161 Alden Road, Units 7 & 8, Markham, Ontario Canada L3R 3W7 Tel: +1 416 754-3322 Fax: +1 416-754-3299 Email: support@edac.net http://www.edac.net ENGINEERING CHANGE NOTICE	
Originator:	Mit Patel	Date:	Document Number
Phone No.	416-754-3322	July 22, 2025	20250702-01
Email Address:	mpatel@edac.net		
Department	Quality	Revision Number	SHEET
		2	1 of 2

DRAWN BY	R.S.M	RJ45 WITH DUAL USB A, SHIELDED					
		DRAWN DATE	2014-11-19						
		CHECKED BY	J.L						
		CHECK DATE	2025-07-25	PART NUMBER	A01-016-261-450				
RoHS COMPLIANT	THESE DRAWINGS AND SPECIFICATIONS ARE THE PROPERTY OF EDAC, AND SHALL NOT BE REPRODUCED , OR COPIED OR USED AS THE BASIS FOR THE MANUFACTURE OR SALE OF APPARATUS WITHOUT WRITTEN PERMISSION	TOLERANCES		ALL DIMENSIONS AND TOLERANCES IN MM	MATERIAL	PBT+G.F.		SIZE	A
		.X	±0.38		REF: ED2708			REVISION	
		.XX	±0.25					R4	
		.XXX	±0.10		SCALE	1:1	SHEET	1	OF

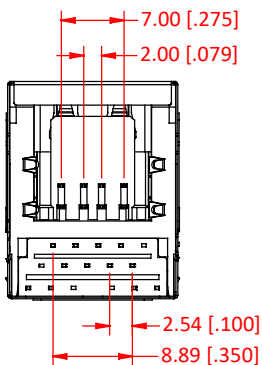
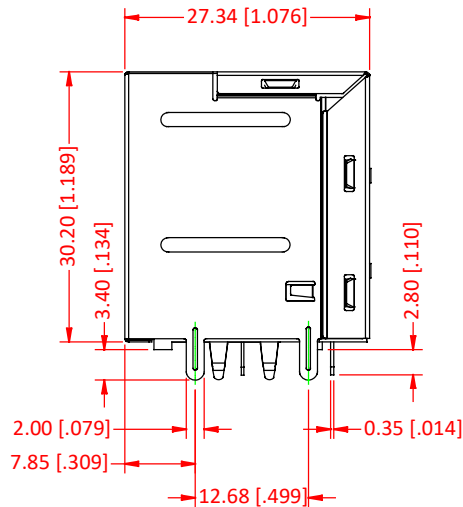
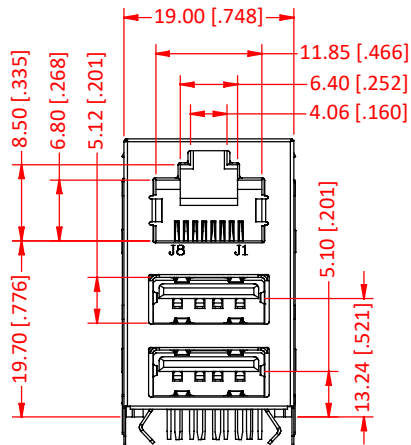
The 15u" and 30u" gold plating options have been made obsolete due to low market demand. Only the gold flash option is available for part A00-016-261-450. There will be no form, fit, and function affects due to this change.

REVISIONS			
REV.	DESCRIPTION	DATE	BY
1	ORIGINAL	DRAWN DATE	R.S.M
2	5.10 WAS 4.60	2014-12-23	R.S.M
3	UPDATED HOUSING & INSERT MATERIAL	2025-07-02	J.S.M
4	REMOVE A01-016-361-450 (15μ" GOLD) & A01-016-661-450 (30μ" GOLD)	2025-07-25	J.S.M
